# PEACH BOTTOM

SAFETY EVALUATION FOR MOD 2564  
PEACH BOTTOM ATOMIC POWER STATION  
UNITS NO. 2 & 3  
Revision 1

SAFETY EVALUATION FOR MODIFICATION 2580  
PEACH BOTTOM ATOMIC POWER STATION UNITS 2 & 3

SAFETY EVALUATION FOR MOD 2579  
DELAY START OF D-G VENT SUPPLY FANS  
PEACH BOTTOM ATOMIC POWER STATION

FIGURE 1

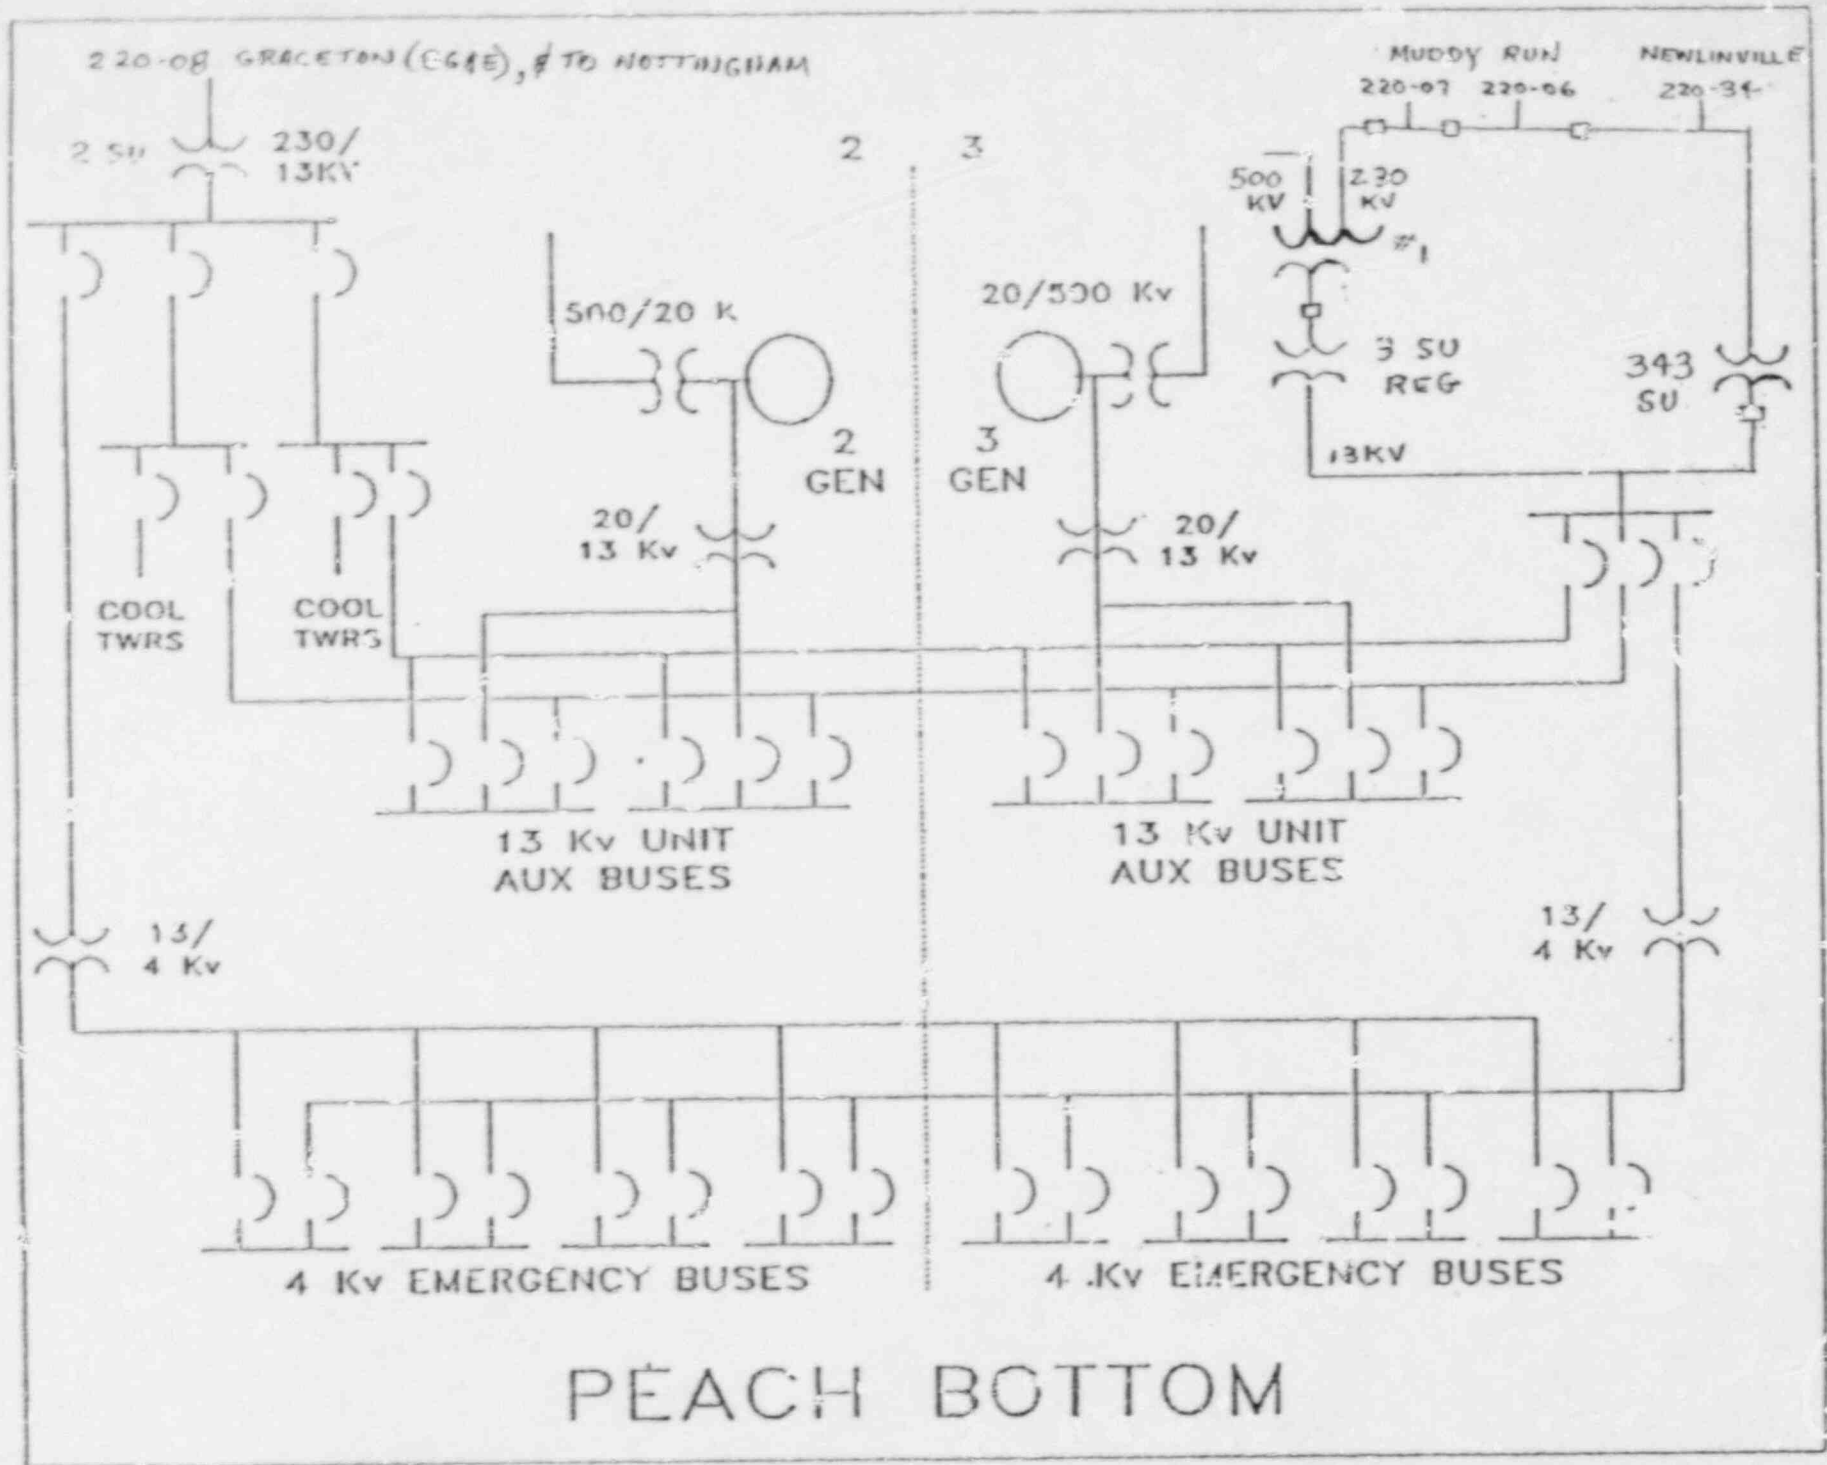
The Emergency Aux. Power Source Degraded Voltage trip function prevents damage to safety-related equipment in the event of a sustained period of low voltage. The voltage supply to each of the 4kV buses will be monitored by undervoltage relaying. With a degraded voltage condition on the off-site source, the undervoltage sensing relays operate to initiate a timing sequence.

The timing sequence provides constant and inverse time voltage characteristics. Degraded voltage protection includes: (1) An instantaneous relay (27N) initiated at 89% voltage which initiates a 60-second time delay relay and a 9 second time delay relay. The 9-second time delay relay requires the presence of a safety injection signal to initiate transfer; (2) An inverse time voltage relay (CV-6) initiated at 87% voltage with a maximum 60 second delay and operates at 70% voltage in 30 seconds; and (3) An inverse time voltage relay (IAV) initiated at approximately 60% voltage and operates at 1.8 seconds at zero volts.

When the timing sequence is completed, the corresponding 4kV emergency circuit breakers are tripped and the emergency buses are transferred to the alternate source. The 60-second timing sequences were selected to prevent unnecessary transfers during motor starts and to allow the automatic tapchanger on the startup transformer to respond to the voltage condition. The 9-second timing sequence is necessary to prevent separation of the emergency buses from the off-site source during motor starting transients, yet still be contained within the time envelope in PS&R Table 8.5.1.
